## Large Scale Residential Development at Ratoath, Co. Meath Stage 1 Road Safety Audit

Marshall Yards Development Company Ltd.

## **Stage 1 Road Safety Audit**

Figure 2.1 – Key Desire Line for People Walking to / from the Main Access

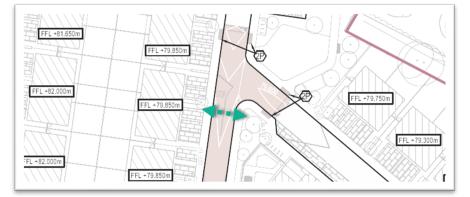
### 2.1 Problem: Facilitating Need for Pedestrians to Cross

#### Location: Internal Street T-Junction Near Main Access

Failing to cater for this key pedestrian desire line connecting the main access to the site could result in slips, trips and progression issues for mobility impaired road users.

An appropriate pedestrian crossing should be provided at the location described above.

3.1	Yes	Yes	A pedestrian crossing point has been added at the subject location. Please refer to the updated DOBA Drawing 2334-DOB-XX-SI- DR-C-0500-0502.	Comment noted with thanks.

Figure 2.3 – Pedestrian Approaching the Crossing from Internal Footpath (Red Arrow)

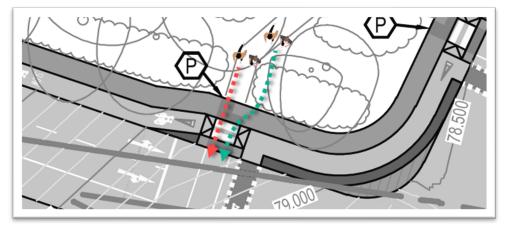
#### 2.3 Problem: Conflicts for Pedestrians Joining the Public Footpath

#### Internal Footpath Connection to South-East Corner of Main Site Location:

Pedestrians approaching a green pedestrian crossing light may cross the footpath and cycle track without checking for approaching walkers and cyclists. This could increase the risk of conflict between pedestrians and cyclist at this location.

The internal footpath connection point should be offset to the right (see green arrow above), to encourage pedestrians to look towards the footpath and cycle track they are about to cross.

3.3	Yes	Yes	The alignment of the footpath has been changed to be off-center from the crossing point at this junction. Please refer to the updated DOBA Drawing 2334-DOB-XX-SI-DR-C-0500-0502.	Comment noted with thanks.

Figure 2.4 – Possible Opposition Conflict Scenario at Access Connection Point to Public Road

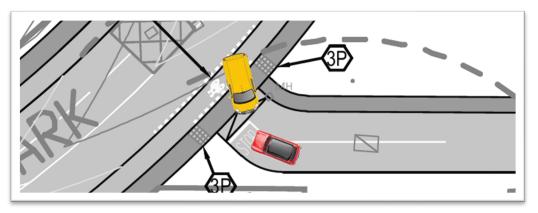
#### 2.4 Problem: Access Approach Geometry & Opposition Conflicts

#### **Private Access - Southbound Exit from New Signal Controlled Junction**

The low radius horizontal curve immediately in advance of the stop line could lead to Stop line 'overshoots' and opposition type conflicts between vehicles entering and exiting the access simultaneously.

The radius of the horizontal curve immediately in advance of the stop line should be increased to mitigate the risk described.

3.4	Yes	Yes	The kerb radii immediately east of the Stop Sign have been increased to flatten out the approach angle and mitigate any possible conflicts. Please refer to the updated DOBA Drawing 2334-DOB-XX-SI-DR-C-0500-0502.	Comment noted with thanks.
